Sent: Tuesday, 20 July 2021 10:46 AM
To: Council Mailbox <council@northernbeaches.nsw.gov.au>
Subject: DA2021/0680 submission objecting to the proposed development

I object to development application DA2021/0680 from a point of view that the site is completely unsuited to the proposed purpose.

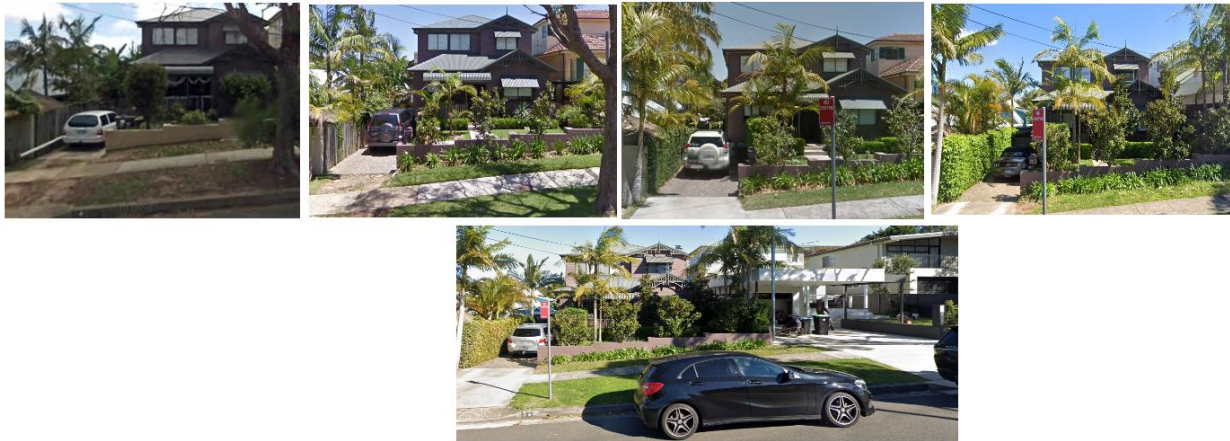
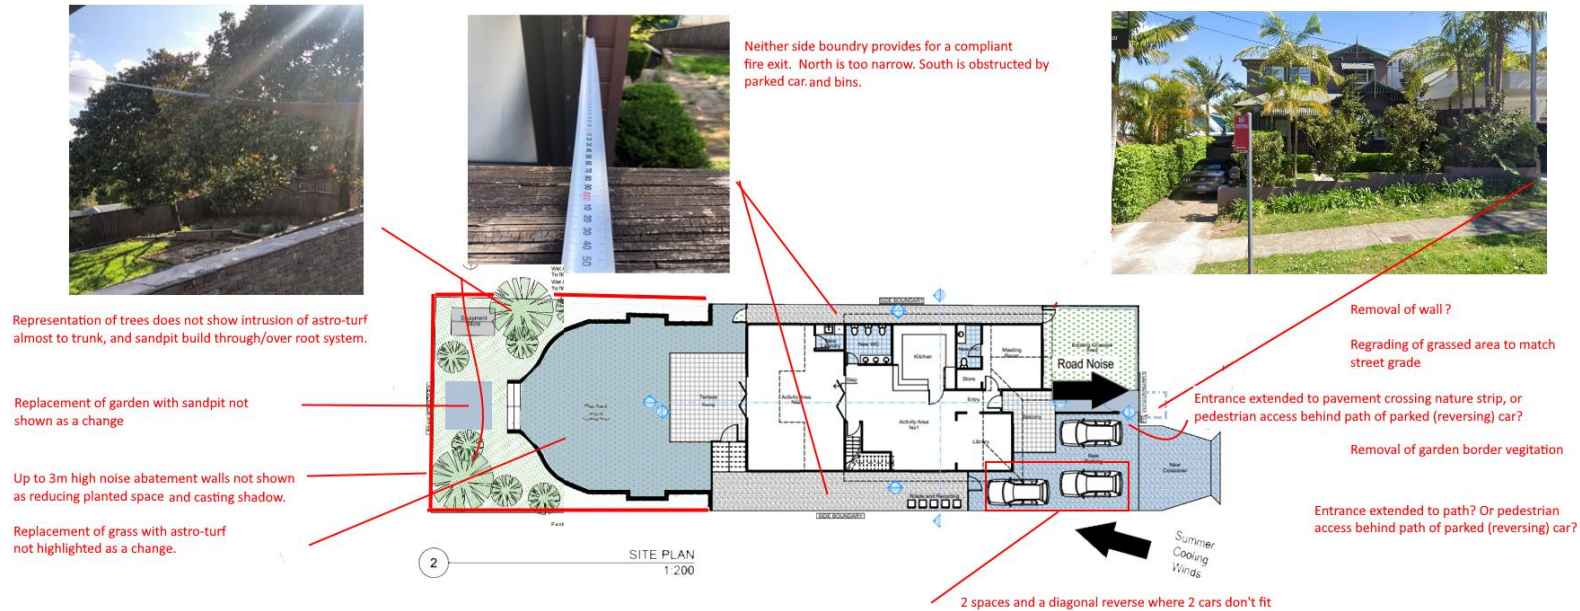
In review of the previous withdrawn DA2020/1397, Council remarked that “as there is no survey plan provided indicating the existing impervious areas on the site, it is unclear if there is an increase in impervious area for the proposal” ... and “Development Engineers cannot support the application due to insufficient information and non-compliance with Clauses C2 and C4 of Warringah DCP” ... and **“Calculations are to be provided to demonstrate the increase in impervious area for the proposal”.**

Despite this, there are **still no plans that show measurements**. Measurements would allow for a more accurate assessment of the proposal, and to make calculations where it seems like the proposal could be non-compliant or marginal. Instead of measurements, the applicants use ambit claims in many areas of their submission.

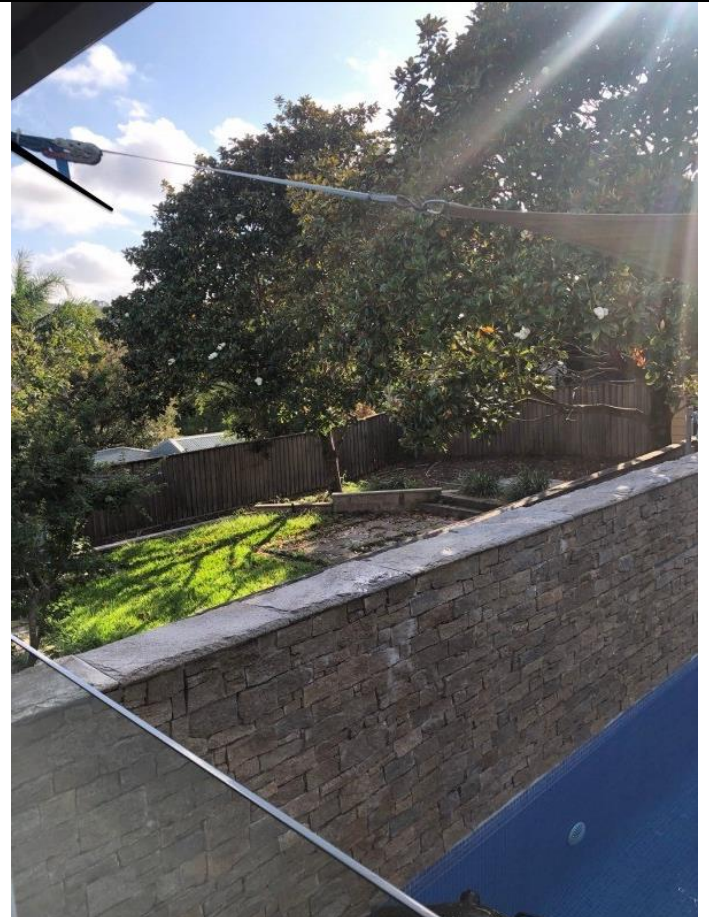
- a. The trees in question are Magnolia Trees which have tasty looking seed pods.

Whereas Childcare Planning Guideline 4.10 Regulation 113 says:

“Shrubs and trees selected for the play space must be safe for children. **Avoid plant species that risk the health, safety and welfare of the facility’s occupants, such as those which:**

- are known to be poisonous, produce toxins or have toxic leaves or berries
- have seed pods or stone fruit, attract bees, have thorns, spikes or prickly foliage or drop branches”

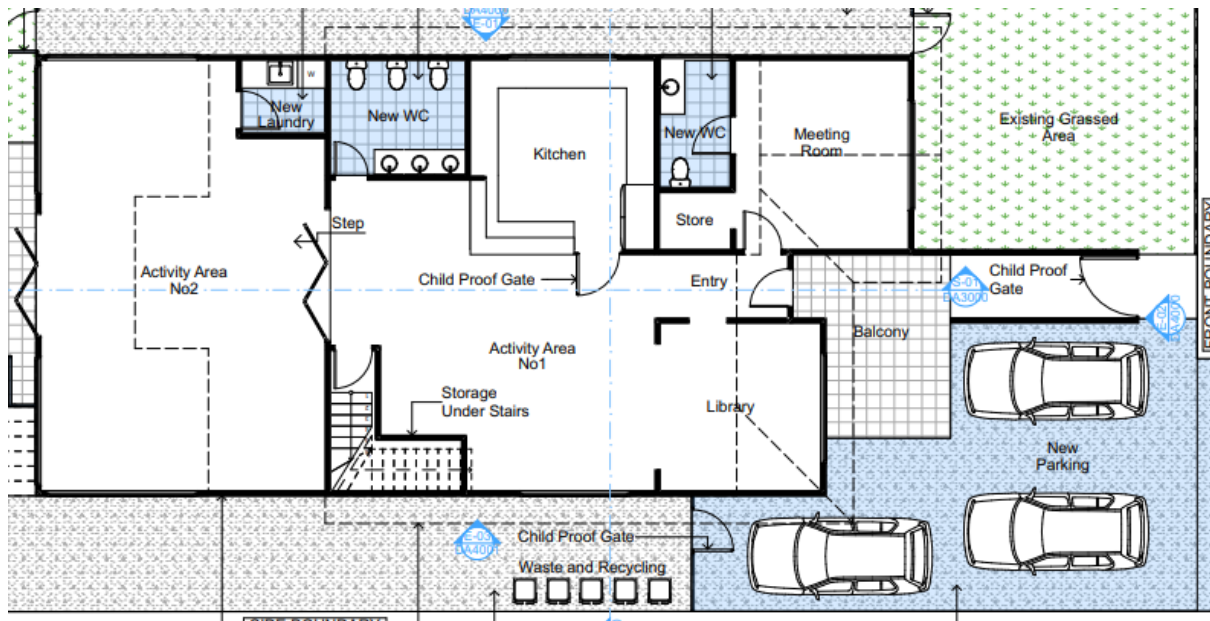
Due to the poor quality of the plans it may not have been apparent that the replacement of lawn with Astro-turf appears to be in the TPZ of both trees, and that the excavation required to provide a suitable base for astro-turf would most likely breach this condition, not to mention the effect of Astro-turf above the tree root zone for the longer term.

Note the border of the proposed Astro-turf area is very close to the trunk of the tree in view and this is set back further than the other tree.

Formation of an Astro-turf base requires excavation up to 100mm with crushed rock fill then compacted.

This does not sound very compliant with the conditions of Council's conditions to protect these trees.

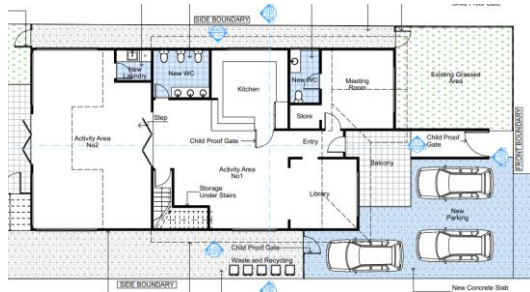
It does not seem possible that he plans as submitted can yield an evacuation plan that is in accordance with regulations given the following

The South pathway is blocked (by bins, and a parked car)

The North pathway is too narrow to be a compliant exit
